<b>Project</b>	Steamboat Base Village Redevelopment	<b>Date</b>	07/30/2021
<b>Project Location</b>	Steamboat, Colorado	<b>Architect's Project Number</b>	03.7835.000
<b>Owner/Client</b>	Alterra Mountain Company / East West Partners	<b>File</b>	6BL <b>This is page</b> 1 of 3
<b>To</b>	Saunders Construction Inc.	<b>Attention</b>	Bryan Sculthorpe
<b>Address</b>	86 Inverness Place North		
<b>City</b>	Englewood	<b>State</b>	CO <b>Zip Code</b> 80112
<b>Delivered via:</b>	<input type="checkbox"/> Messenger	<input type="checkbox"/> Hand carried	<input type="checkbox"/> Facsimile
	<input type="checkbox"/> Express	<input type="checkbox"/> Pick-up	<input type="checkbox"/> E-mail Address
	<input type="checkbox"/> Mail	<input type="checkbox"/> UPS	<input checked="" type="checkbox"/> Website Address BIM360

**Attachments** BP3 PROMENADE - BULLETIN 06

## Description of Changes

- Updated steel for plaza building revisions
- Updated plaza building footprint and shaft opens
- Added slab step plan
- Updated underground MEP to match Bulletin 06

**1A-S0.02**

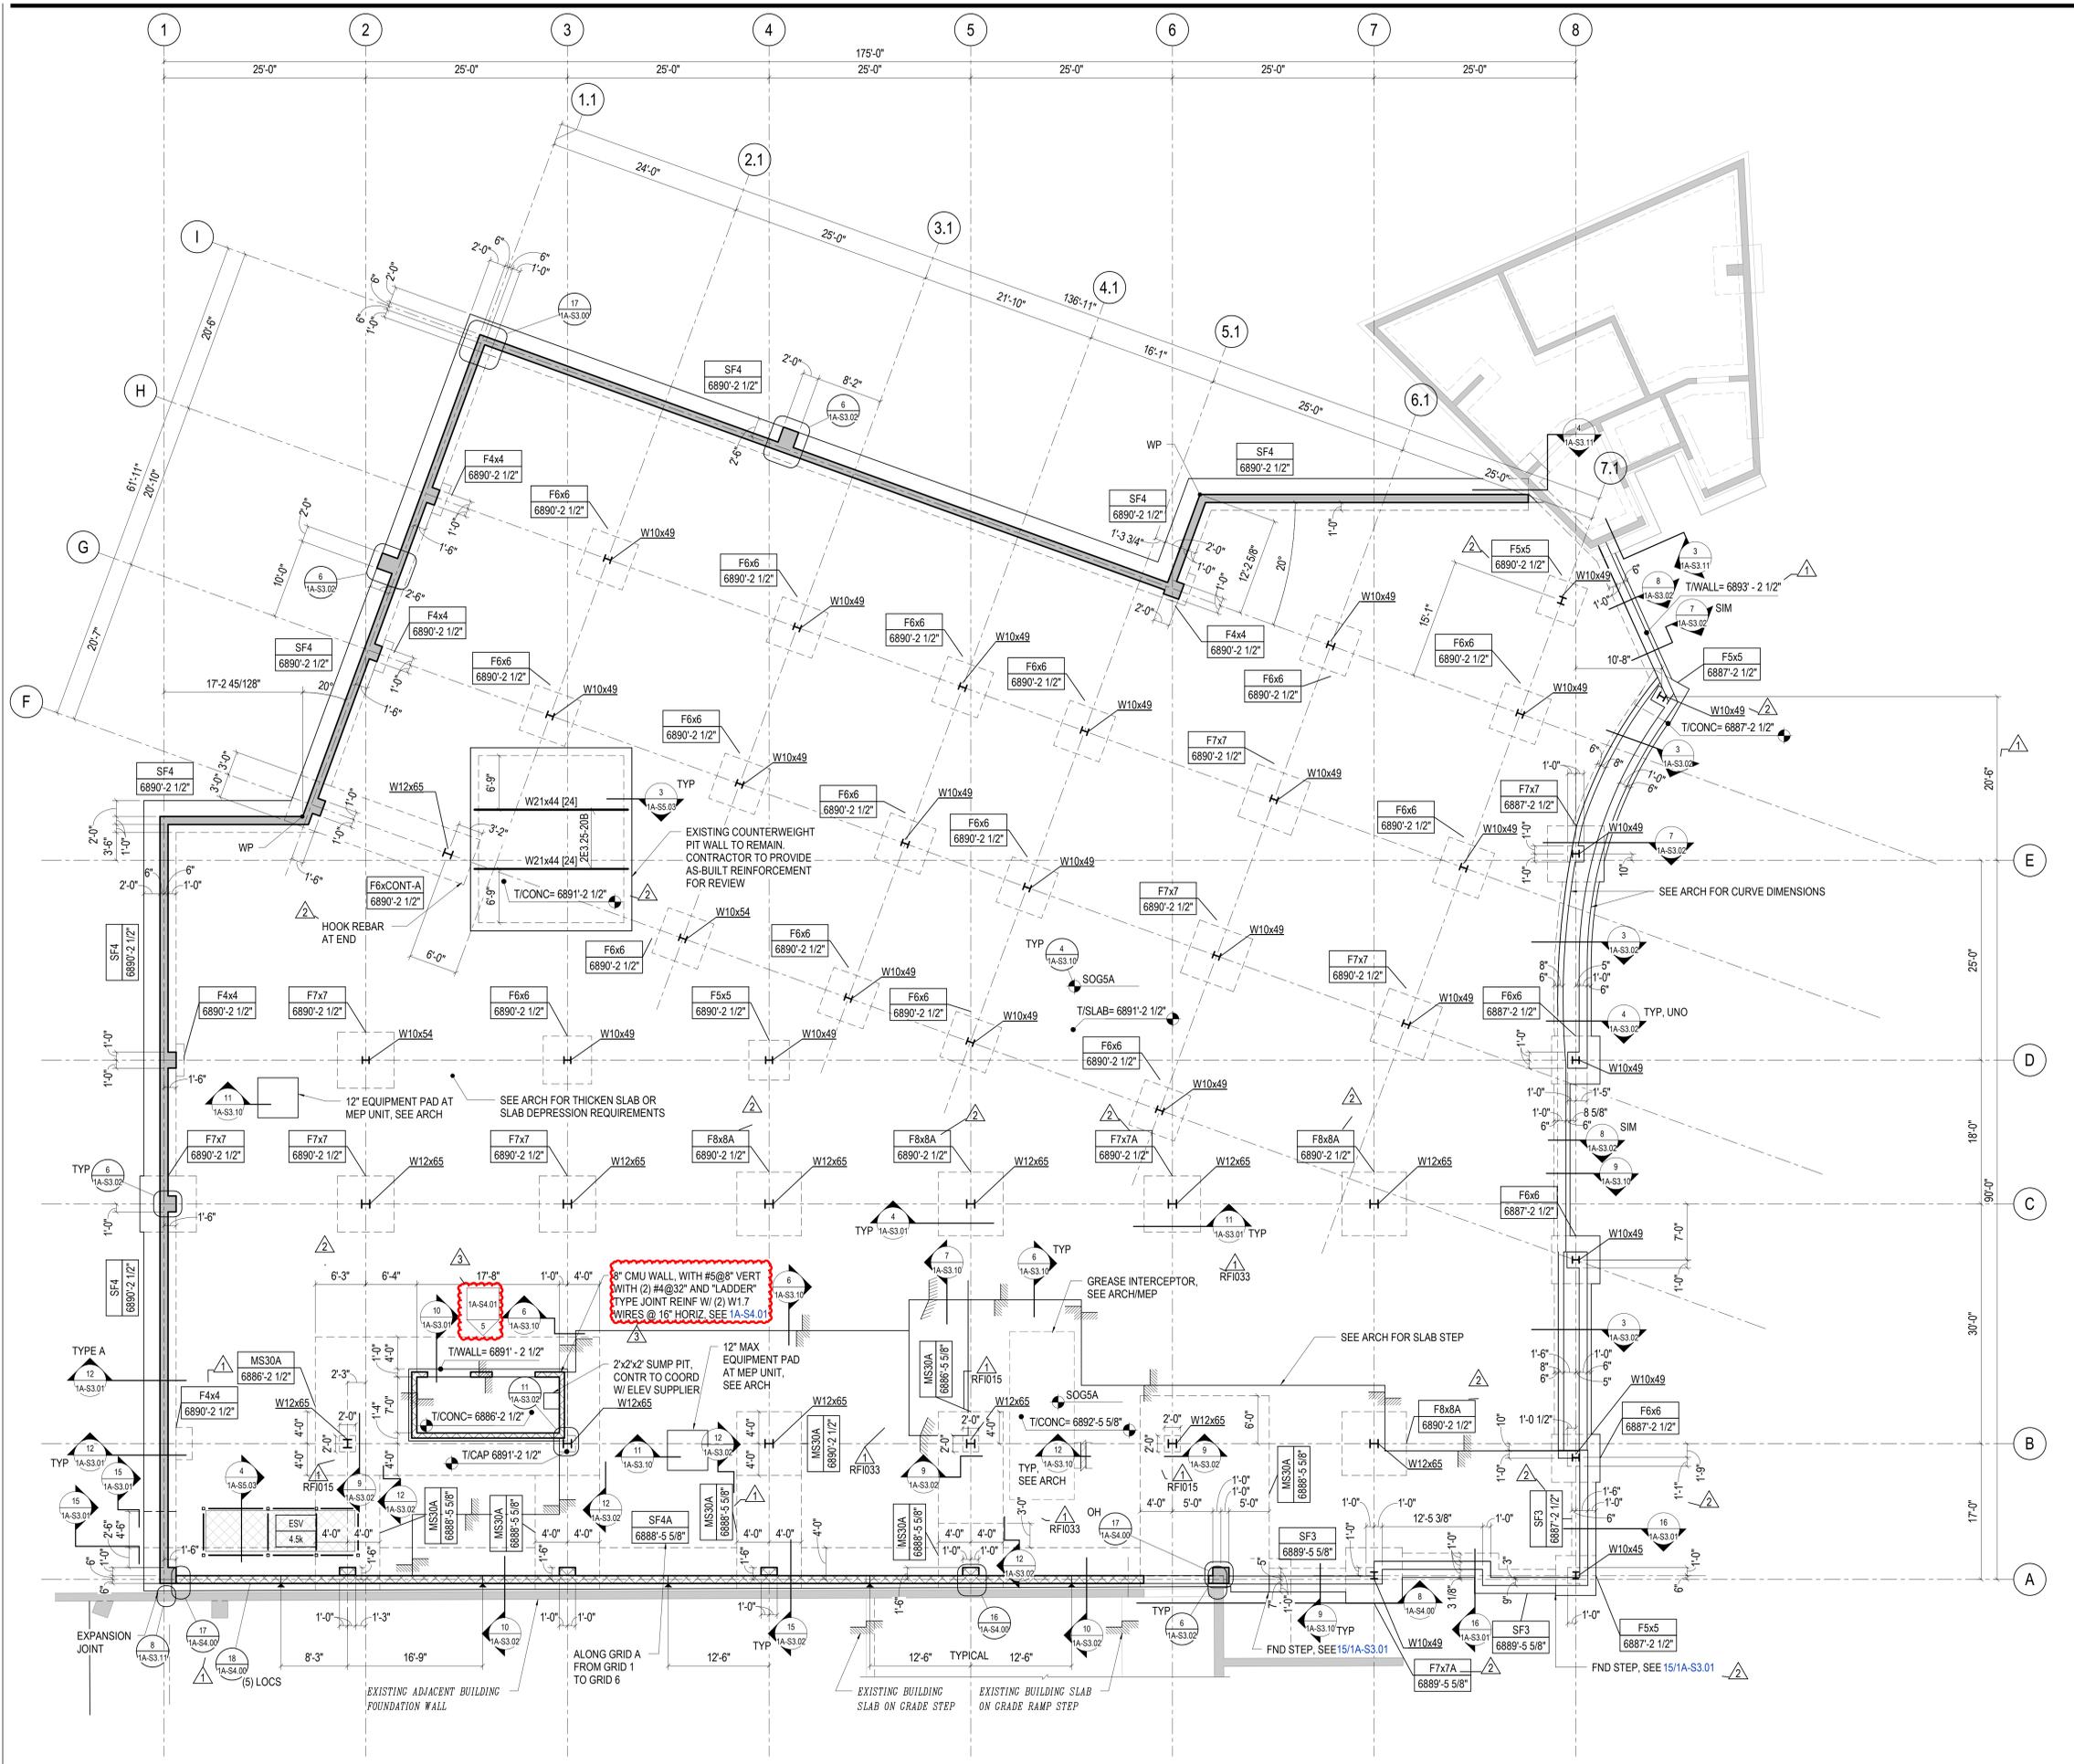
1. 1A-S0.02
  - a. Retail/Food court loading area is updated to match architectural plan.
2. 1A-S1.00
  - a. Elevator structural CMU wall requirement is updated.

**1A-S1.00**

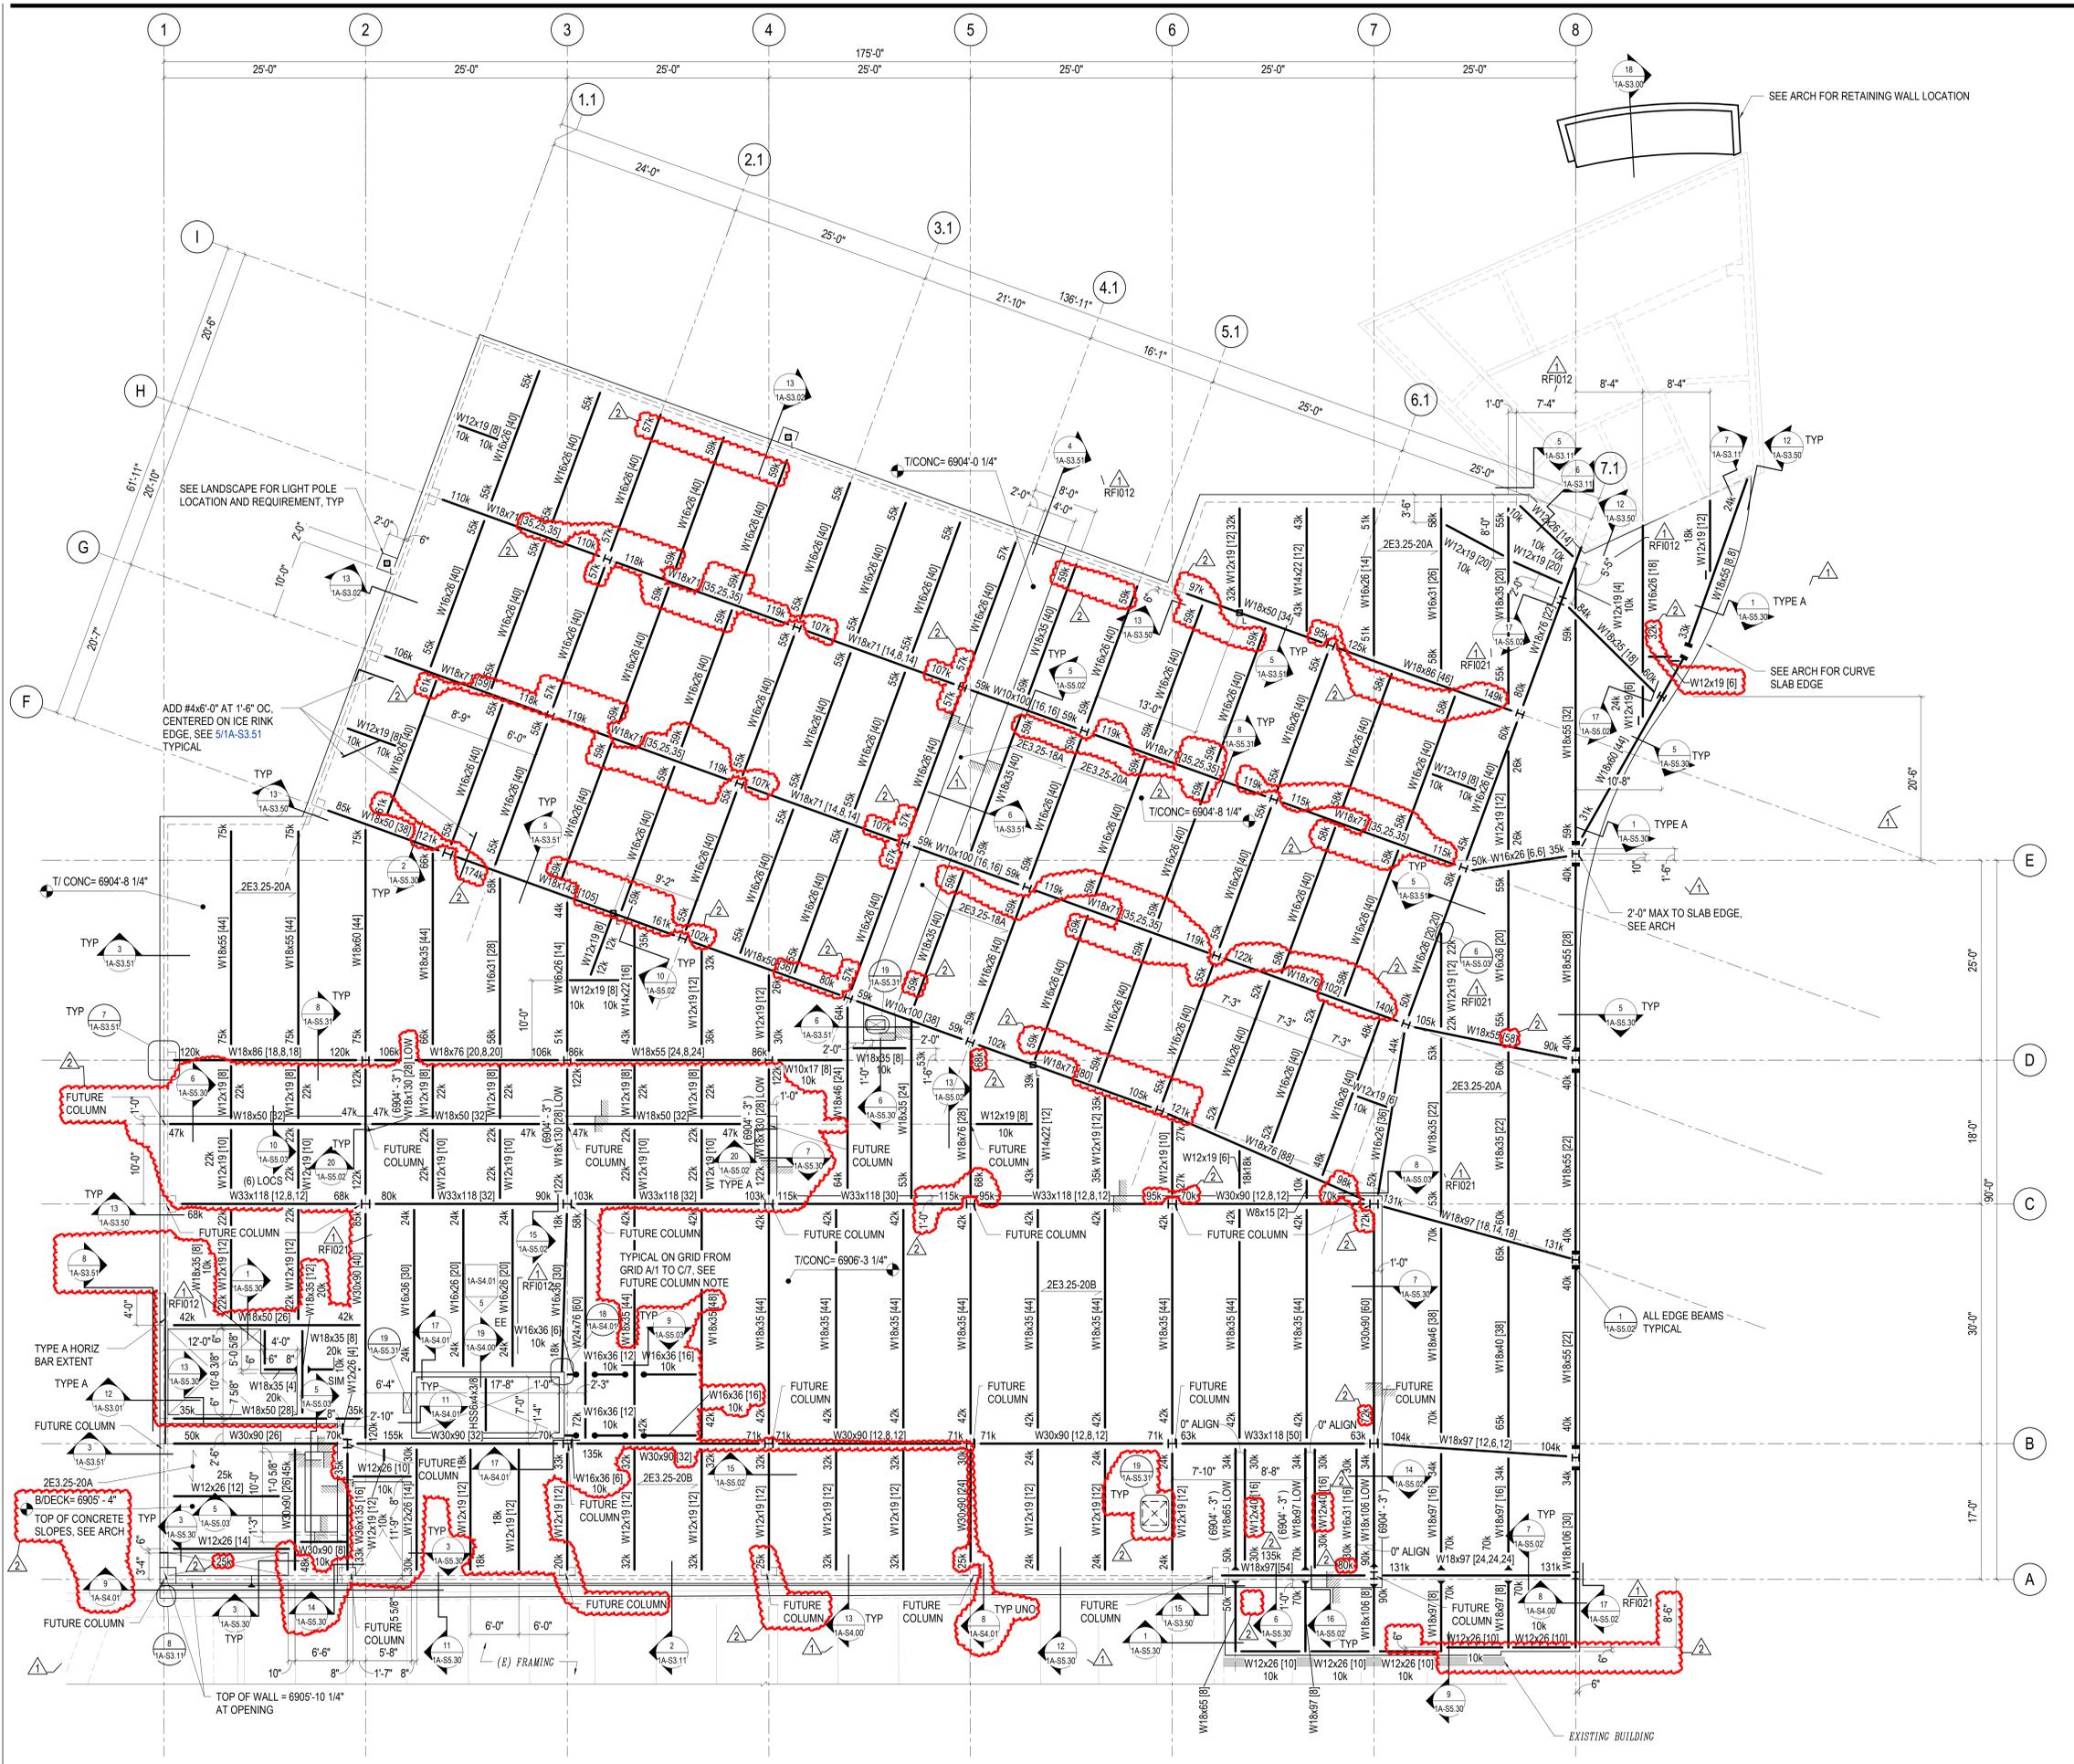
- b. CMU wall opening elevation is added.
3. 1A-S1.01
  - a. W12x19 steel beam size and reaction are clarified at grid E.5/8.5.
  - b. At outdoor ice rink, steel beam stud requirements and reaction loads are revised.

**1A-S1.01**

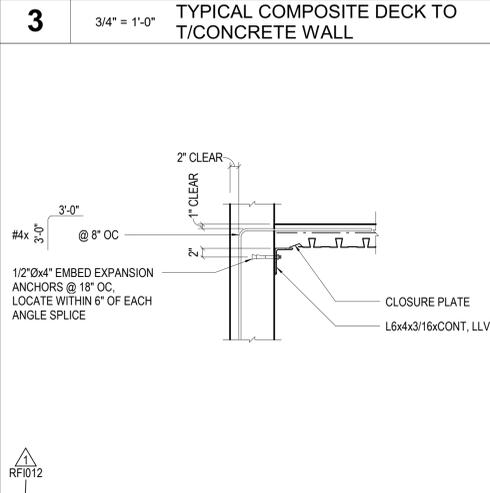
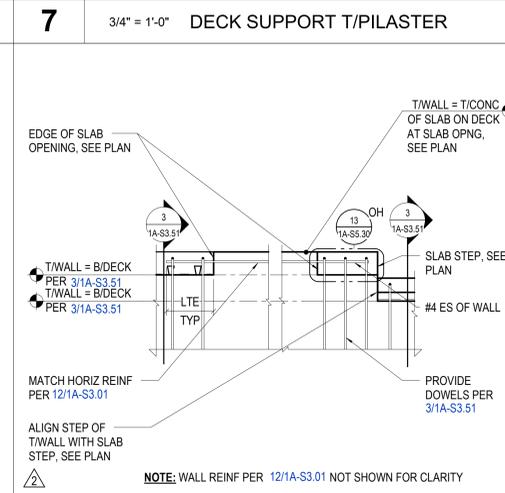
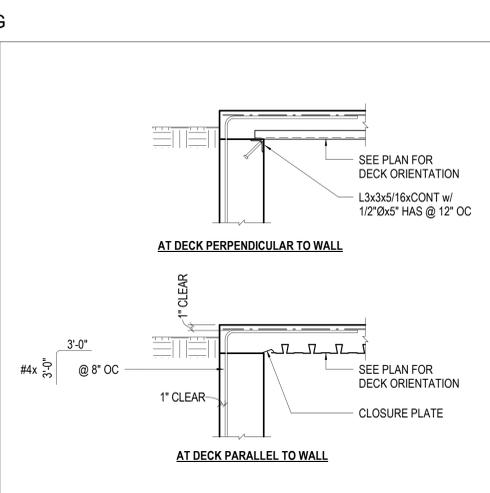
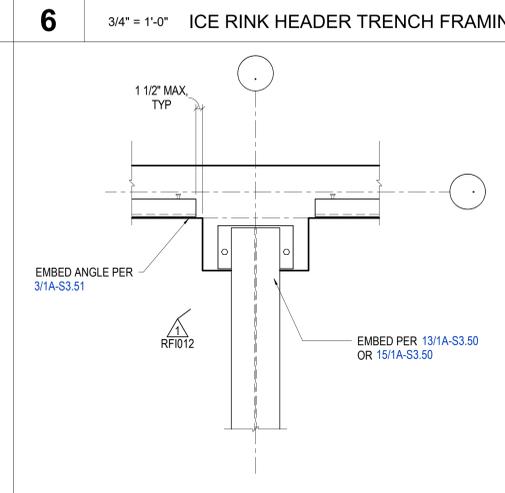
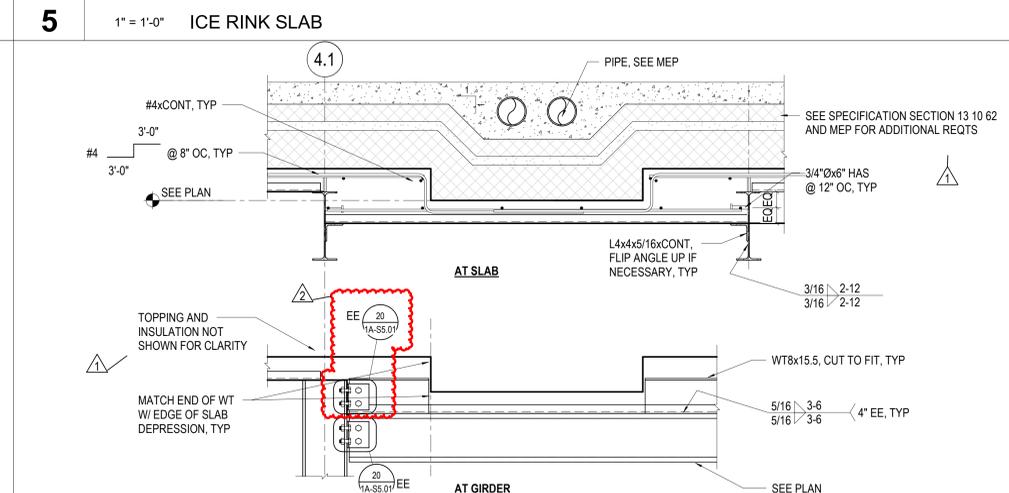
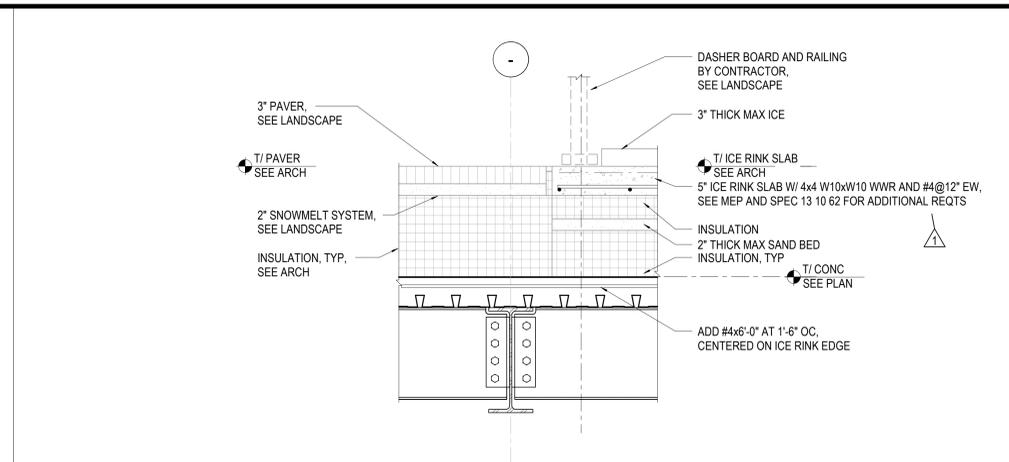
- c. Slab step is relocated to grid C.5/1 to C.5/4. Steel framing are updated.
  - d. Stair opening and steel framing are revised per updated architectural plan.

- e. Steel framing around the elevators is revised.
  - f. Steel framing around the slab opening at grid A/2 is revised.
  - g. Bottom of deck at grid 1.5/A.5 is revised to match architectural plan.

- h. Slab step along grid B is removed. Steel framing is revised.
  - i. Slab edge at grid A/8 is revised to match architectural plan.
4. 1A-S3.50
  - a. Detail 12: Existing wall and field welding symbol are clarified.

**13** 1" = 1'-0" MASONRY BEAM BEARING

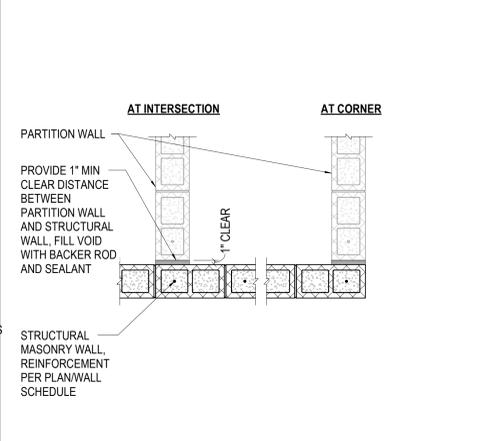
- b. Detail 8: Detail added.
6. 1A-S4.00
  - a. Detail 9: Bottom of CMU wall requirement is clarified.
  - b. Detail 13: Bearing plates are clarified.
  - c. Detail 15: Composite deck orientation is clarified.

**9** 1 1/2" = 1'-0" STEEL DRAG CONN

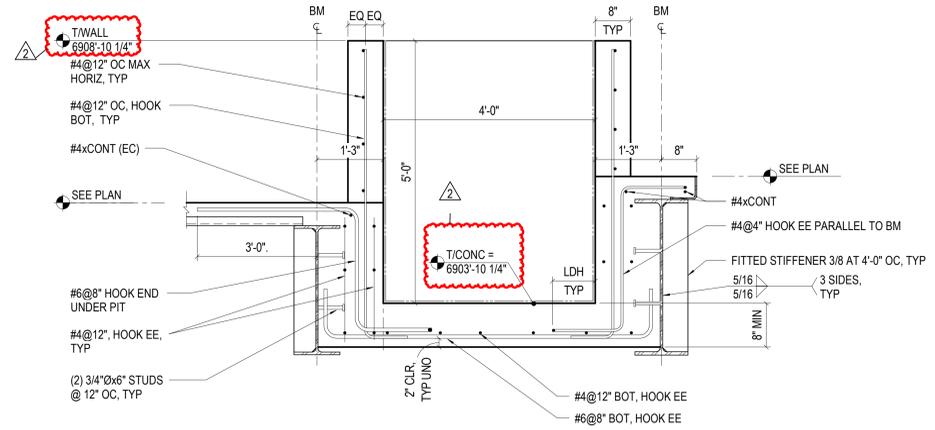
- a. Detail 5: Top of pit wall and top of pit slab elevations are added.
- b. Detail 9: Detail added.
- c. Detail 10: Detail added.
- 10. 1A-S5.30:
  - a. Detail 5: Cold formed and stone angle is revised per RFI039.
  - b. Detail 10: Detail removed.
  - c. Detail 11: Top of slab updated.
  - d. Detail 13: Detail added.
  - e. Detail 14: Detail added.
- 11. 1A-S5.40
  - a. Detail 13: Stone angle is updated per RFI039.
